1964 - 1966 Corvette: Service Bulletin: Reverse Lockout Mechanism Revised

Model and Year: 1966 Corvette (4-Speed Transmission)

Bulletin No: TSB #66-10

Date: November 29, 1965

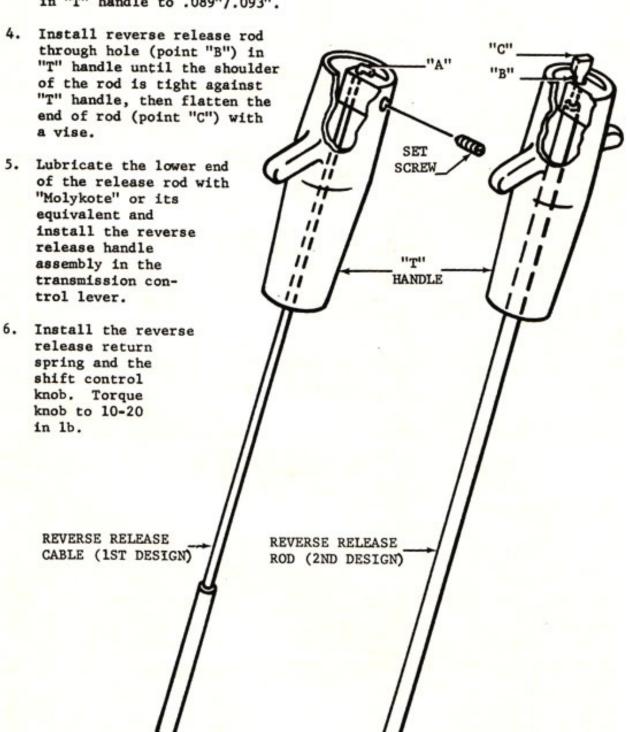
The reverse lockout mechanism for the Corvette 4-speed transmission was revised interim 1966 production. In the early design mechanism, the reverse release cable position is normally controlled by a set screw in the "T" handle. However, should the set screw loosen, this design doesn't insure cable movement with handle movement. Should the cable remain in the up position, accidental selection of reverse gear would be possible.

To eliminate this possibility, the reverse release cable has been replaced by a reverse release rod. The lower diameter of the reverse release rod is larger than the hole in the "T" handle. This larger diameter forms a shoulder and when the "T" handle is released, the rod is forced downward. This design eliminated the set screw and insures the reverse release rod will be lowered whenever the "T" handle is down.

The reverse release rod, Part No. 3889461, may be used in place of the reverse release cable on 1964-65 and early 1966 Corvettes. Instructions for installing the reverse release rod are outlined on page2.

- Remove the reverse release handle assembly by first removing the shift control knob and the reverse release handle return spring.
- Straighten the release cable (point "A"), then remove and discard the set screw and reverse release cable.
- If necessary, enlarge the release cable hole (point "B") in "T" handle to .089"/.093".
